Groundwater Transfer Review Summary Form

Transfer/PA # T- 14915

Ground Water Review Form:

Applicant Name: Lakebrook Holdings LLC

Map

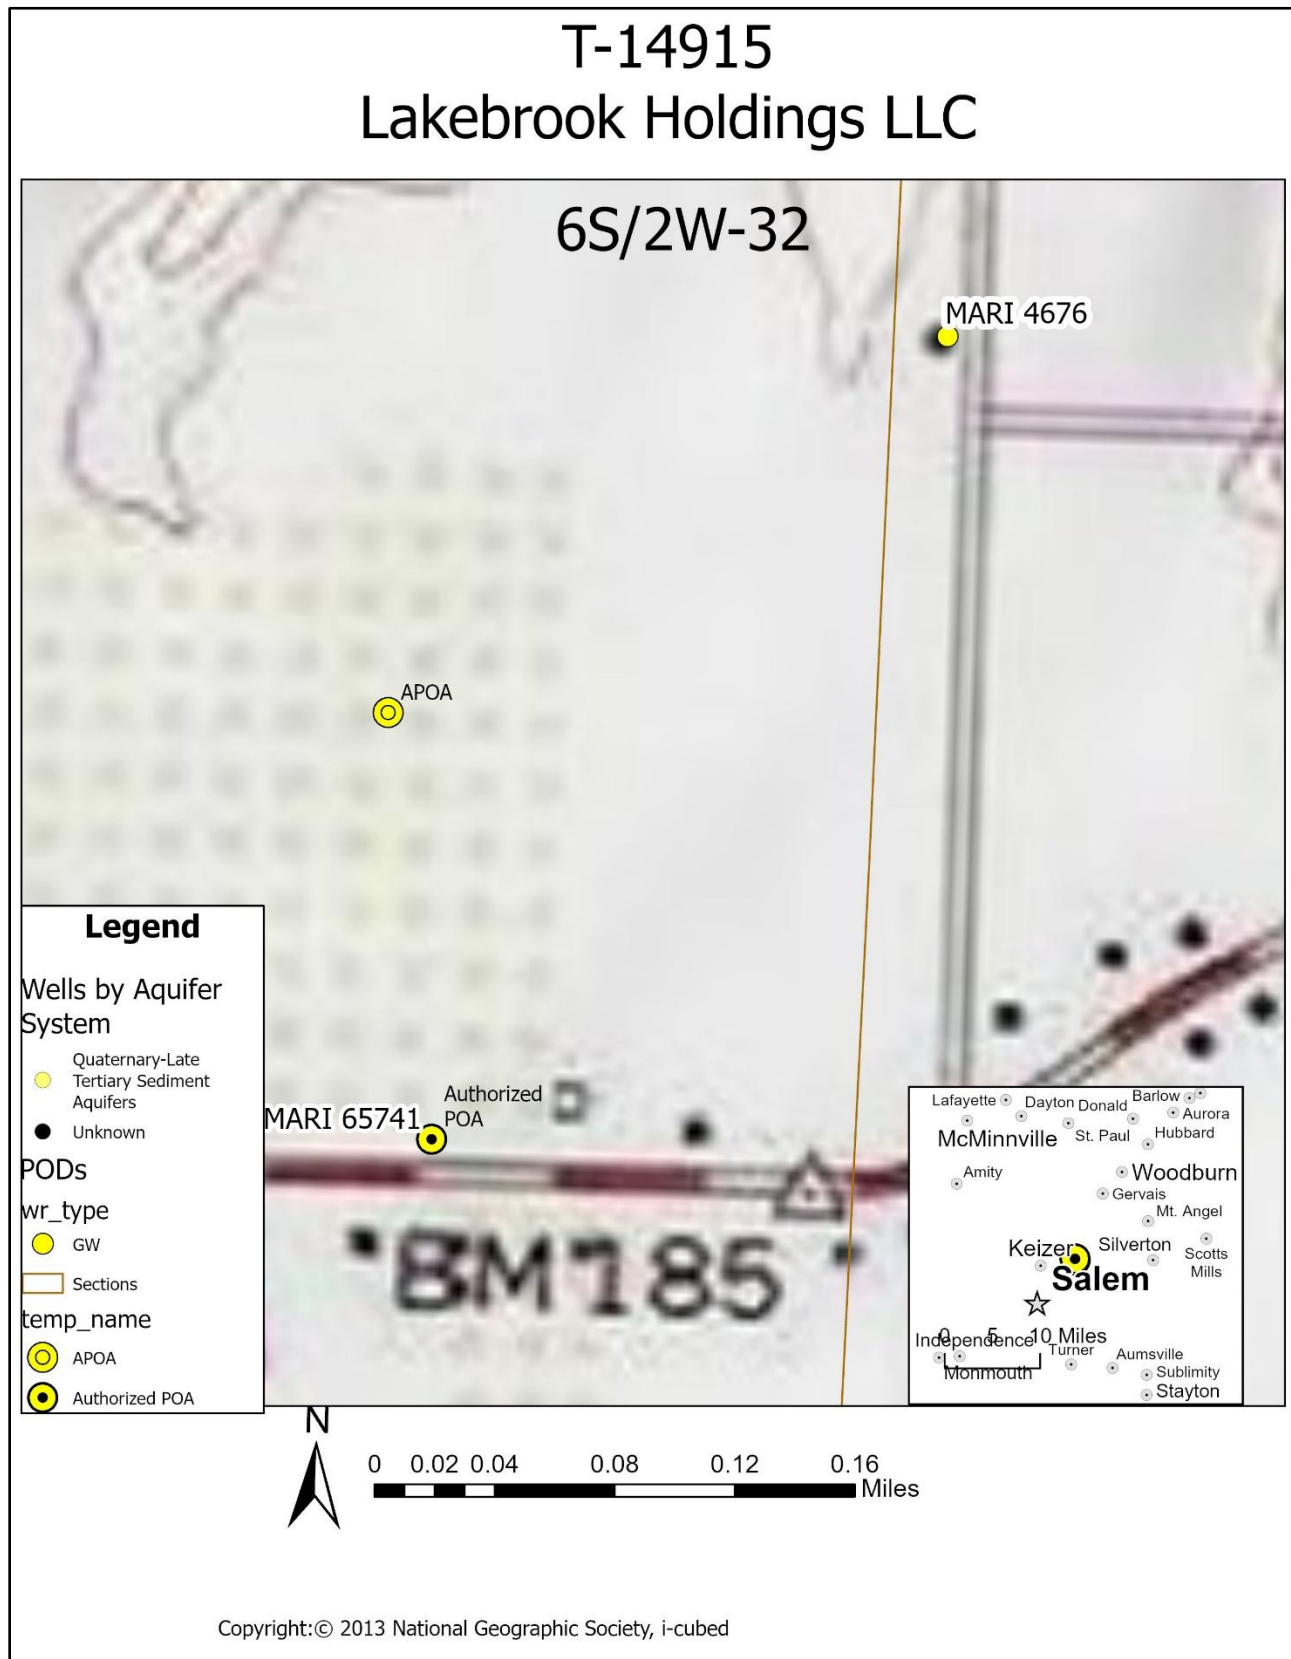
-
1. Basic description of the changes proposed in this transfer: Applicant proposes to add APOA Well 2/**PROP 876**, not yet drilled to **Certificate 95614**. **Certificate 95614** authorizes irrigation of 49.7 ac at a maximum rate of 0.62 cfs (278 gpm) and a maximum annual duty of 124.25 AF by the authorized POA Well 1/**MARI 65741**.

2. Will the proposed POA develop the same aquifer (source) as the existing authorized POA?
☒ Yes ☐ No Comments: The authorized POA Well 1/**MARI 65741** develops the Willamette Aquifer from 51 to 160 ft bls [28 to 137 ft amsl]. The proposed APOA Well 2/**PROP 876** is anticipated to develop the same aquifer with an open interval of 50 to 200 ft bls [-15 to 135 ft amsl].

☒ Yes ☐ No Comments: J. The proposed APOA Well 2/PROP 876 is closer to MARI 4676, a POA on Certificate 34076 with priority date 8/31/1962. The reduced distance is anticipated to increase interference with MARI 4676.

8. What conditions or other changes in the application are necessary to address any potential issues identified above: Require monitoring and reporting of March water levels from the APOA Well 2/**PROP 876** with same decline conditions as required of the authorized POA Well 1/**MARI 65741**. With start of measurements from APOA Well 2/**PROP 876**, re-start monitoring and reporting of March water levels from the authorized POA Well 1/**MARI 65741**. Reference level in APOA Well 2/**PROP 876** to be set based on first year of water use of the water right (2017) and corresponding to extrapolated water level at location of APOA Well 2/**PROP 876**.
9. Any additional comments: N/A

Theis Interference Analysis

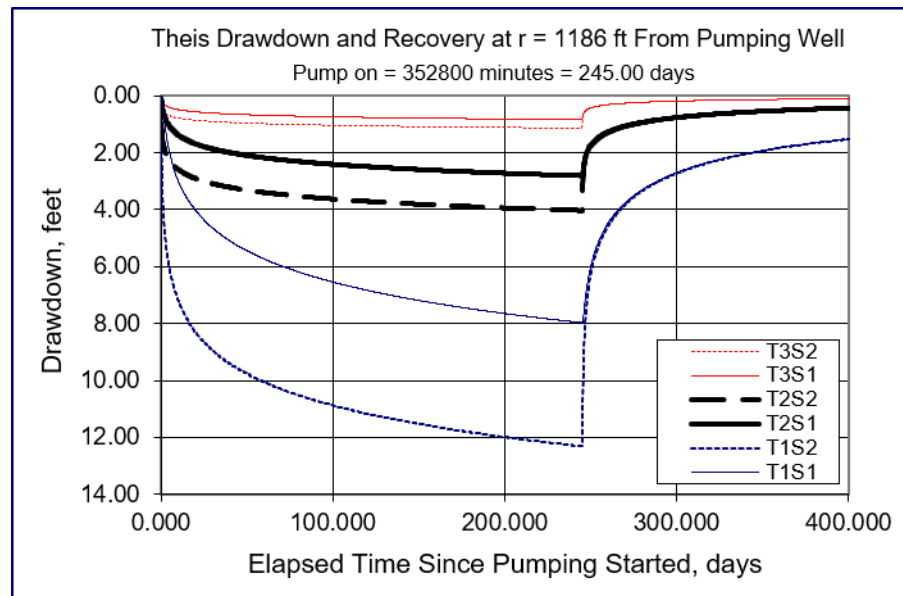
☐ Yes ☒ No If yes, explain: The proposed change was analyzed using the Theis (1935) solution for drawdown in a confined aquifer (see attached Theis Well Interference Analysis). Hydraulic parameters used for the analysis were derived from regional data and studies (Pumping Test Reports; Conlon et al., 2005; Iverson, 2002; McFarland and Morgan, 1996; Woodward et al., 1998). Results of the analysis indicate that pumping the proposed APOA Well 2/PROP 876 is not likely to result in injury at the location of MARI 4676.

The full rate of 0.62 cfs (278 gpm) could not be used over the full 245-day irrigation season without exceeding the 124.25 AF annual volume. For the duration of the 245-day irrigation season, the average rate of 0.255685 cfs (115 gpm) could be used without exceeding the 124.25 AF annual volume.

SWL	43 ft bls	MARI 4676
Aquifer Bottom	440 ft bls	Woodward et al, 1998
Available Water Column	397 ft	Aquifer bottom-SWL
Pump Height Above Bottom	5 ft	Estimate
NPSHa	5 ft	Estimate
Drawdown	36 ft	Estimate
Minimum Water Column	46 ft	Estimated Drawdown + NPSHa + Pump Height
Injury	351 ft	Available Water Column-Minimum Water Column
